IMPORTANT SAFETY NOTICE

NHTSA CAMPAIGN NUMBER 07C006

August 2007

Graco Children's Products Inc. ("Graco") has decided that certain ComfortSport™ Car Seats ("child restraint systems") fail to conform with Federal Motor Vehicle Safety Standard (FMVSS) No. 213, Child Restraint Systems. Our records indicate that you may own one of the affected child restraints.

INCORRECT ROUTING FOR REAR-FACING MODE

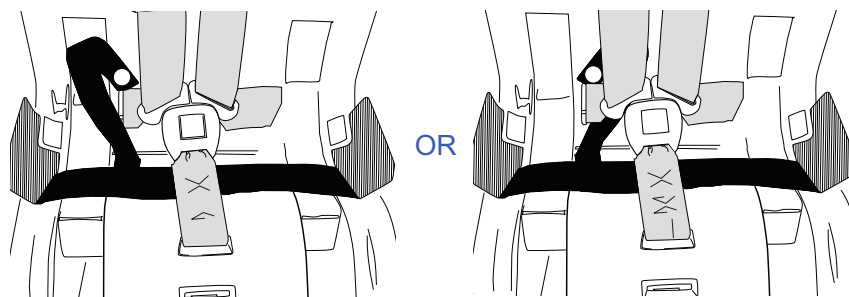
On some of these child restraints, the Lower Anchorage belt was misrouted under the shoulder portion of the harness during assembly, instead of under the crotch belt/buckle section of the harness. If the child restraint is installed in the rear-facing mode and the Lower Anchorage belt is attached to the vehicle's LATCH anchor, the seat back angle of the child restraint can exceed 70 degrees in a frontal crash. This increased rotation may increase the risk of injury to the child.

Remove the seat pad and refer to the following pictures which show incorrectly routed and correctly routed Lower Anchorage belts. If your child restraint has an incorrectly routed Lower Anchorage belt (with the belt routed behind the shoulder portion of the harness), reroute the Lower Anchorage belt as described in Step 3. If the routing is already correct, reinstall the seat pad making sure you reattach using all the connections. Please refer to your ComfortSport Instruction Manual to reinstall your child restraint in your vehicle. If you do not have an Instruction Manual, go to www.gracobaby.com or call 1-800-345-4109.

Remove the Lower Anchorage belt from behind the harness straps and place it under the crotch strap portion of the harness as shown above, keeping the belt flat and tight against the child restraint so that it does not interfere with the harness system. The lanyard attaching the Lower Anchorage belt may be on either the right or left sides of the harness. Depending on which way your lanyard is mounted, assemble as shown above.
